Access Compliance Report

Public Rights-of-Way

(Curb Ramps)

Intersection ID: 13787	Main Street: CHARLOTTETOWNE_AV	Cross Street: E_4TH_ST	Location:	N
ADA ID: CFF896677550	Ramp Type: Perp	Initial Pass/Fail: Pass	Overall Compliance: No	Severity Score: 7.75

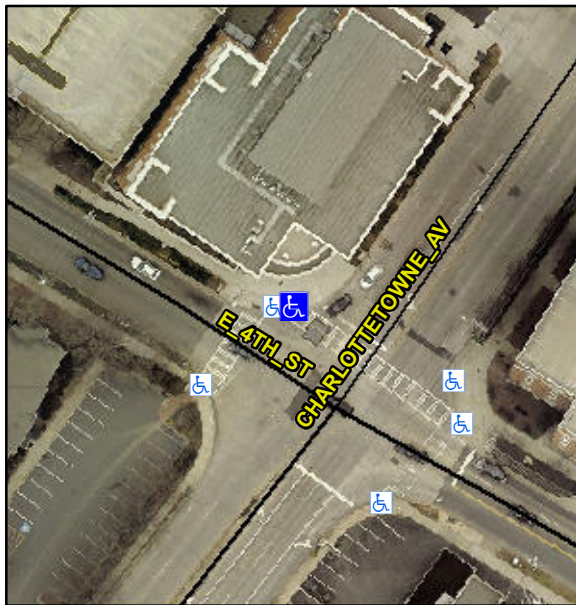
**Not Found, R304.5.3, R304.2.3,
R304.5.4**

Compliance	Description	Data	Compliance	Description	Data
N/A	Ramp Length (in)	96.0	Yes	Ramp Slope (%)	6.7
Yes	Ramp Width (in)	60.0	No	Ramp XSlope (%)	3.1
N/A	Flare Type LT	Sloped	N/A	Flare Type RT	N/A
N/A	Flare Slope LT (%)	4.8	No	Flare Slope RT (%)	10.4
N/A	Flare Traversable LT?	Yes	N/A	Flare Traversable RT?	Yes
Yes	Landing Length (in)	51.5	Yes	DWS Provided?	Yes
Yes	Landing Width (in)	52.5	Yes	DWS Contrast?	Yes
Yes	Landing Slope (%)	1.1	Yes	DWS Length (in)	24.0
Yes	Landing X Slope (%)	1.6	Yes	DWS Full Width?	Yes
N/A	Landing Curb? (Y/N)	No	Yes	DWS Offset (in)	1.0
N/A	Shared Landing?	No			
Yes	Gutter Ponding?	No	No	Gutter Slope (%)	6.6
Yes	Gutter Lip Ht (in)	0.0	Yes	Gutter X Slope (%)	1.0
N/A	Painted X Walk1?	Yes	N/A	Painted X Walk2?	N/A
	X Walk 1 Direction	To SE		X Walk 2 Direction	N/A
N/A	X Walk 1 Width (in)	120.0	N/A	X Walk 2 Width (in)	N/A
	X Walk 1 Slope (%)	0.0		X Walk 2 Slope (%)	N/A
	X Walk 1 X Slope (%)	0.5		X Walk 2 X Slope (%)	N/A

**Remove & Replace Entire Ramp.
Remove & Replace Gutter.**
